PRODUCT/PROCESS CHANGE NOTIFICATION

PCN IPG-DIS/14/8468
Dated 06 May 2014

Power Rectifiers

Additional Assembly and Test Location in China for DPAK package

DPAK dimensions

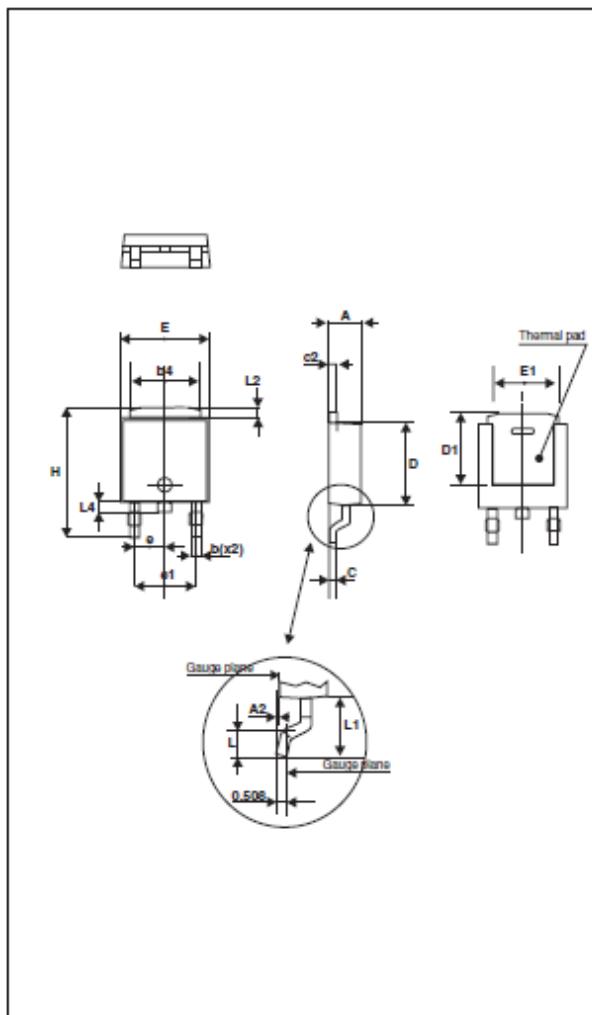
Type of change	Additional assembly package location																																																													
Description of the change																																																														
STMicroelectronics decided to expand the manufacturing capacity Power Rectifiers (Power Schottky and Ultrafast Diodes) housed in DPAK package with one additional assembly and test plant in China.																																																														
In order to cover both manufacturing locations DPAK package outline dimensions, the package dimension table of the impacted products will be updated as below:

NEW DPAK dimensions	Column1	Column2		Dimensions (mm)			Min.	Max.	A	2.18	2.4	A1	0.9	1.1	A2	0.03	0.23	b	0.64	0.9	b4	4.95	5.46	c	0.46	0.61	c2	0.46	0.6	D	5.97	6.22	D1	5.1		E	6.35	6.73	E1	4.32		e1	4.4	4.7	H	9.35	10.4	L	1	1.78	L2		1.27	L4	0.6	1.02	V2	0°	8°
NEW DPAK dimensions	Column1	Column2																																																												
	Dimensions (mm)																																																													
	Min.	Max.																																																												
A	2.18	2.4																																																												
A1	0.9	1.1																																																												
A2	0.03	0.23																																																												
b	0.64	0.9																																																												
b4	4.95	5.46																																																												
c	0.46	0.61																																																												
c2	0.46	0.6																																																												
D	5.97	6.22																																																												
D1	5.1																																																													
E	6.35	6.73																																																												
E1	4.32																																																													
e1	4.4	4.7																																																												
H	9.35	10.4																																																												
L	1	1.78																																																												
L2		1.27																																																												
L4	0.6	1.02																																																												
V2	0°	8°																																																												
Reason for change																																																														
This additional multi-sourcing will increase our manufacturing capacity for a better service on the considered Power Rectifier devices.																																																														
Former versus changed product:	<p>The changed products do not present modified electrical, parameters, leaving unchanged the current information published in the product datasheet</p> <p>The Moisture Sensitivity Level of the part (according to the IPC/JEDEC JSTD-020D standard) remains unchanged.</p> <p>The footprint recommended by ST remains the same.</p> <p>There is no change in the packing modes and the standard delivery quantities either.</p>																																																													
Disposition of former products																																																														
As the purpose is to expand the manufacturing capacity, shipments of the products processed in the initial test and assembly site will continue.
